REPORT TO CITY PLAN COMMISSION

Item: Preliminary Plat – Apple Ridge

Plat Reviewed Dated/Drafted By: 7-27-18 and drafted by James R. Sehloff, P.L.S. No. S-2692

File: 5090Plat.dwg Date: 07/27/2018 Drafted By: jim Sheet: 1 of 1

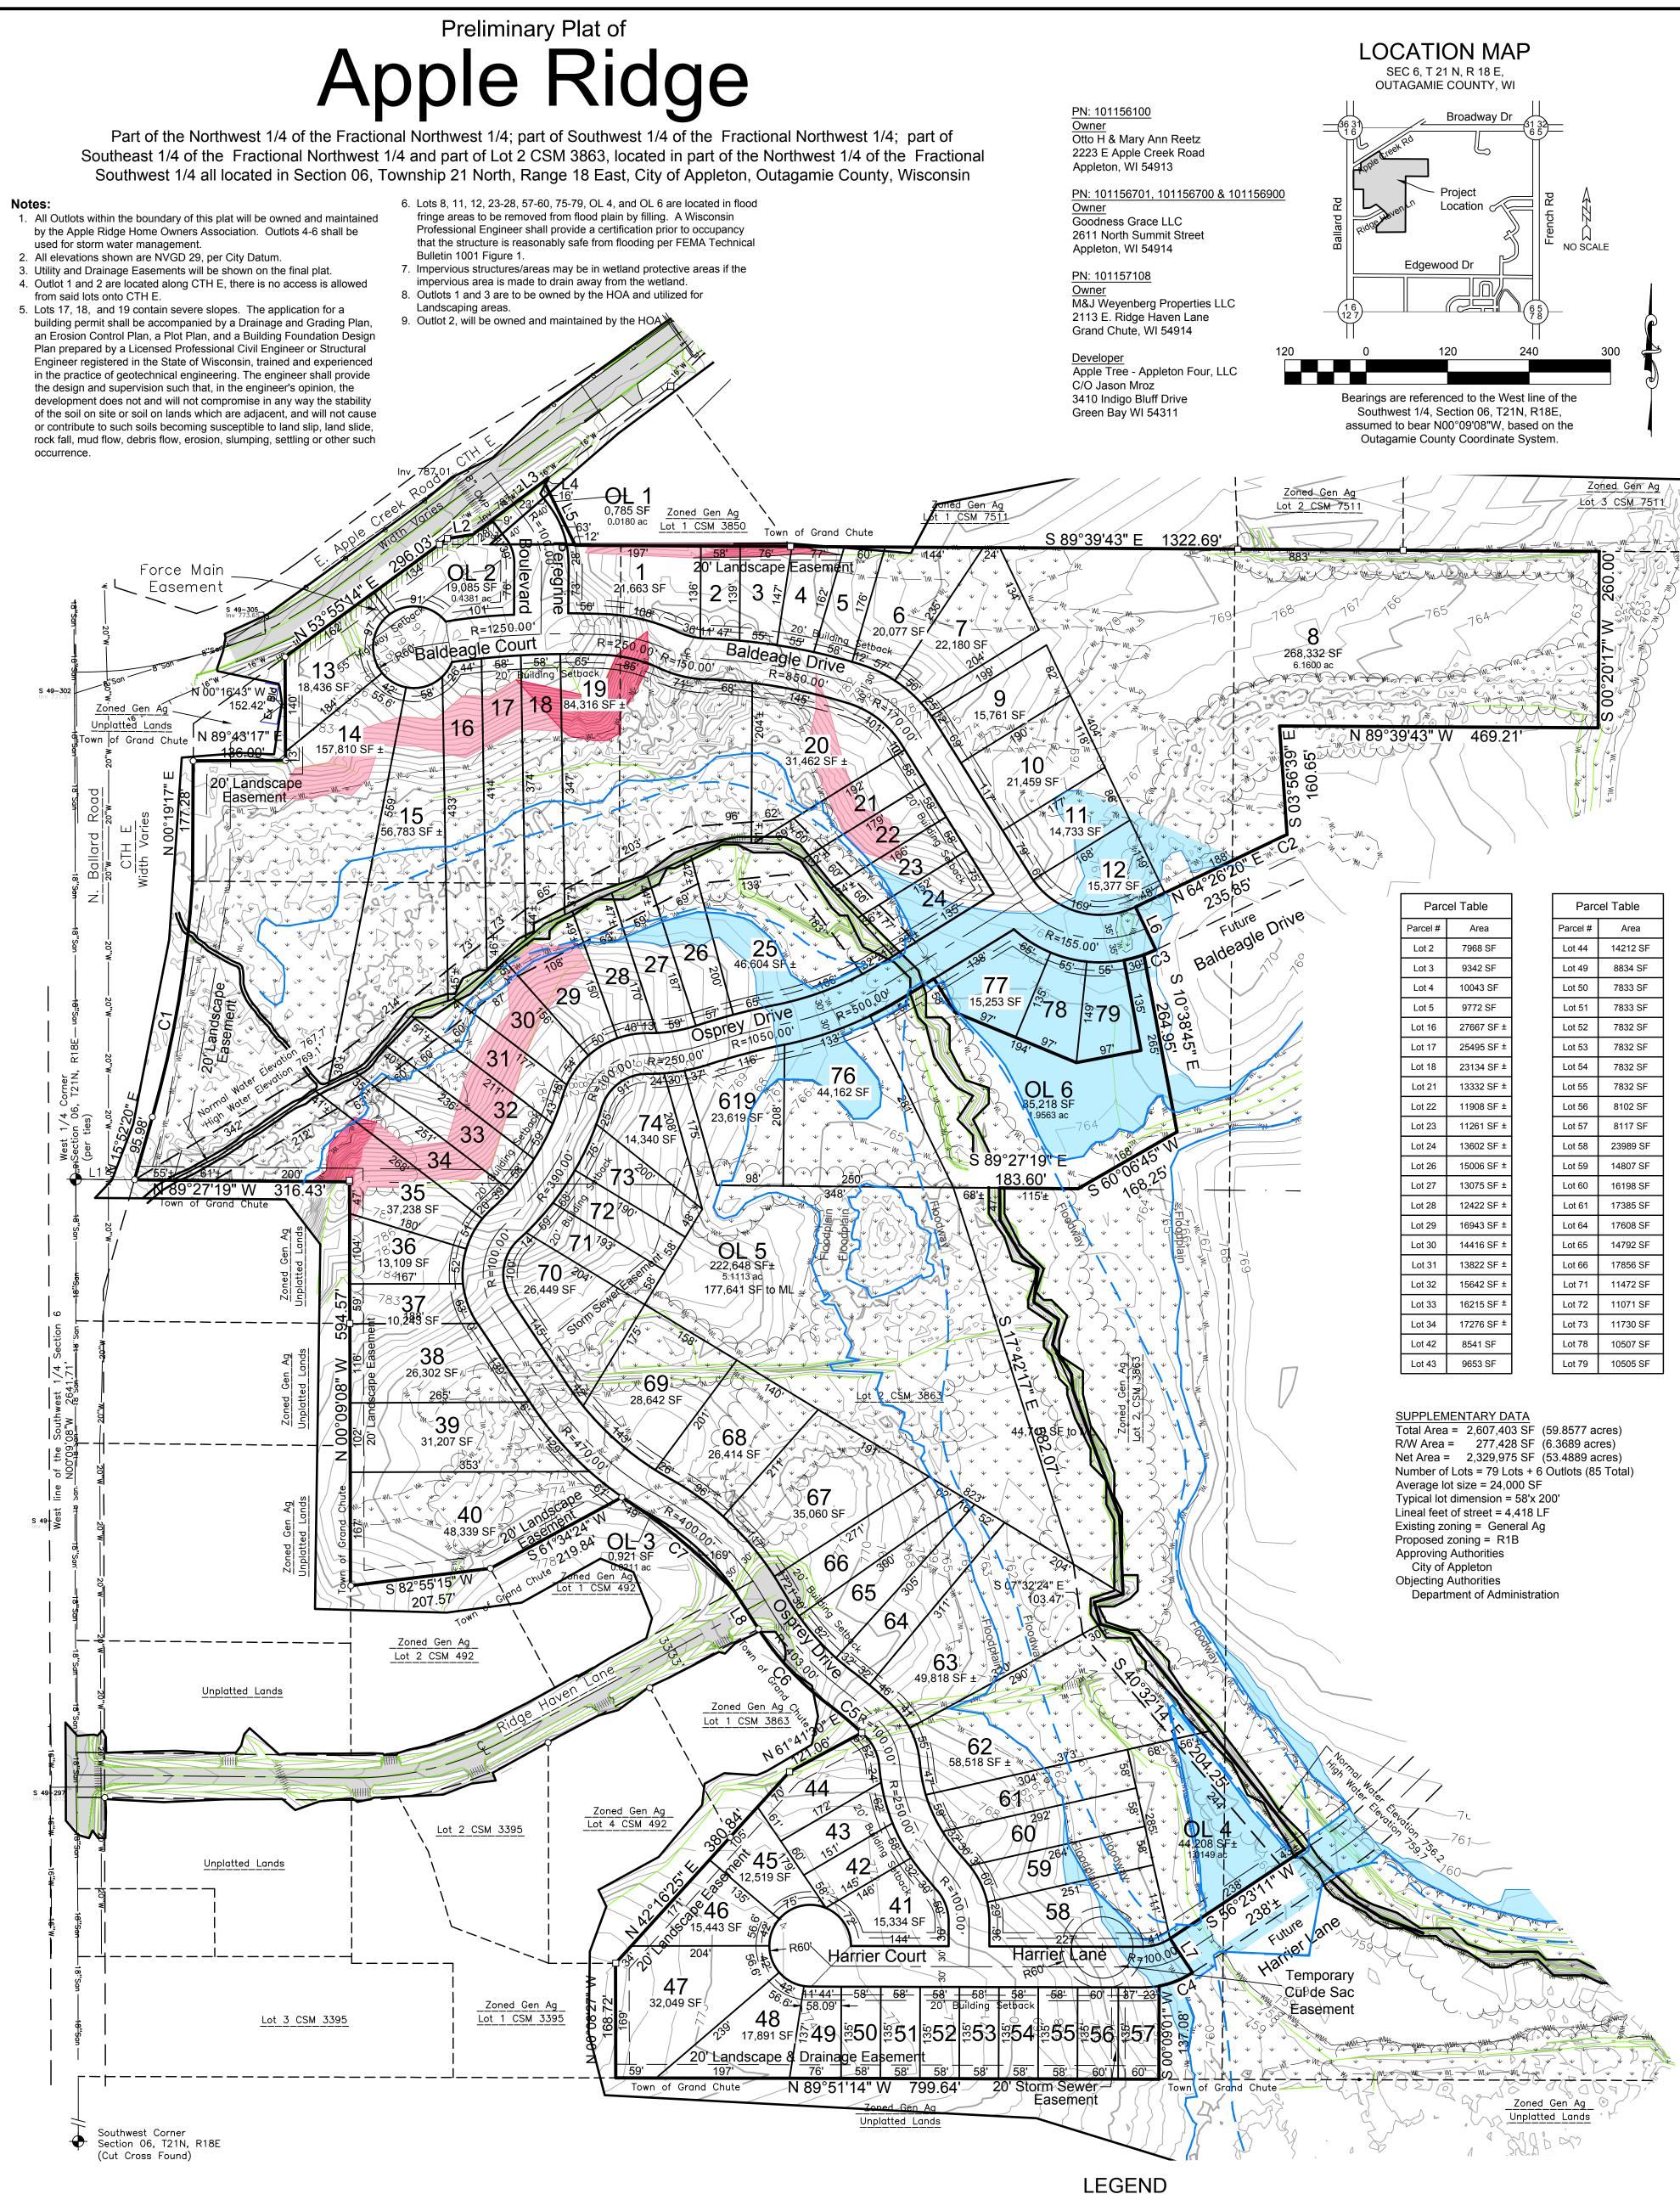
• Proposed lot area for Outlot 1 is 785 square feet, minimum 6,000 square feet is required per Section 17-3(c)(6) and Section 23-93(g)(1) of the Municipal Code. The modification allows for a reduction of lot area from 6,000 square feet to 785 square feet. *Note: Per Preliminary Plat Note #8, this outlot will be owned by the Home Owners Association and used for landscaping.*

- Proposed lot area for Outlot 3 is 921 square feet; 6,000 square feet is required per Section 17-3(c)(6) and Section 23-93(g)(1) of the Municipal Code. The modification allows for a reduction of lot area from 6,000 square feet to 921 square feet. *Note: Per Preliminary Plat Note #8, this outlot will be owned by the Home Owners Association and used for landscaping.*

- Proposed Outlot 4 does not abut a dedicated public street in Phase 1 of this development per Section 17-26 (c)(1) of the Municipal Code requires all lots shall abut on a public street or an approved access. The modification allows for a lot not to abut a dedicated public street temporarily, unless a temporary access easement is proposed. *Note: When Phase 2 is platted, this outlot will abut a dedicated public street. Also, per Preliminary Plat Note #1, this outlot will be used for storm water management.*

- Proposed lot width for Outlot 5 is 30 feet, 50 feet is required per Section 17-3(c)(6) and Section 23-93(g)(3) of the Municipal Code. The modification allows for a reduction of lot width from 50 square feet to 30 square feet. *Note: Per Preliminary Plat Note #1, this outlot will be used for storm water management.*

- Proposed lot width for Lot 8 is 25 feet; 50 feet is required per Section 17-3(c)(6) and Section 23-93(g)(3) of the Municipal Code. The modification allows for a reduction of lot width from 50 square feet to 25 square feet on a temporary basis. *Note: When Phase 2 is platted, this lot will satisfy the minimum lot width requirement.*

- Proposed Lot 42 is a double frontage lot. Section 17-26(c)(2) of the Municipal Code states, "Double frontage lots shall not be permitted except as required by the Common Council where they are desirable to provide separation of development from traffic arterials or inharmonious uses, or to overcome disadvantages of topography or situation. A planting screen easement of at least 20 feet, and across which there shall be no right of access, may be required along the line of lots abutting such traffic arteries or other inharmonious use." *Note: This parcel configuration is necessary to have uniform property lines and avoid unnecessary bend/jogs in the property lines, which lead to ownership confusion in the future. Staff will request a no access restriction note to Harrier Court be placed on the Plat for Lot 42.*

• Per Engineering Division, a Stormwater Permit application with Stormwater Management Plan (SWMP) pursuant to Chapter 20, Article VI of the Municipal Code is required but has not been submitted for review and approval. Revisions to the plat, drainage plan, and storm sewer design may be required based on that review.

- 1. The following information is to be provided on the Final Plat:
 - a. A separate exhibit showing 50' Shoreland Zoning Setbacks.
 - b. A separate exhibit showing Wetland Protective Areas.

- c. A separate exhibit showing Flood Fringe and Floodway, as well as any areas that have been removed from the floodplain via placement of fill.
 - d. On each exhibit, the appropriate line work shall be defined by a metes & bounds description. Each exhibit shall include a statement referencing the corresponding section of the Appleton Municipal Code. The floodplain exhibit shall include a statement that for any structures with basements located within areas removed from the floodplain via fill placement, a Professional Engineer registered in Wisconsin shall submit a statement prior to occupancy that the structure is reasonably safe from flooding, per FEMA Technical Bulletin 10-01, Figure 1.

- e. Label the meander lines or place in the legend identification for the meander lines.
 - f. Label the watercourse.
 - g. The Public Trust statement shall be included with all Plats that have a navigable stream, revise as necessary.

- h. The location map does not appear to match the plat limits, revise as necessary.
 - i. Clarify the Easterly limits of Outlot 5, revise line type as necessary.

- j. Outlot 4 does not have public access, revise as necessary or provide a temporary access easement.
- k. List the outside diameter of iron pipes found.

- 1. Provide an Ordinary High Water Mark (OHWM) Statement. At a minimum, the statement shall provide the source of the determination and if it is approximate. See State Statute 236.025 for additional detail.

- m. Renumber Lot 619 to Lot 75.
- n. Add a note indicating there is no access allowed from Harrier Court to Lot 42.
- o. Add a separate category identifying slopes of 20% and greater to the final plat and add affected lot numbers to Note #5.

The Apple Ridge Preliminary Plat, as shown on the attached maps, **BE APPROVED** subject to the following conditions:

- 2. The Stormwater Management Plan and Stormwater Permit Application pursuant to Chapter 20, Article VI shall be submitted to the City of Appleton Engineering Division for review and approval prior to the Final Plat being scheduled for Plan Commission or Common Council approval.

- 3. Grant all modifications listed in the staff report for Outlots 1, 3, 4, 5, and Lots 8 and 42.
- 4. The calculation of land area for each lot (pre-filled condition) that is at least two (2) feet above the one hundred (100) year reoccurrence interval flood elevation shall be submitted with the Final Plat materials.
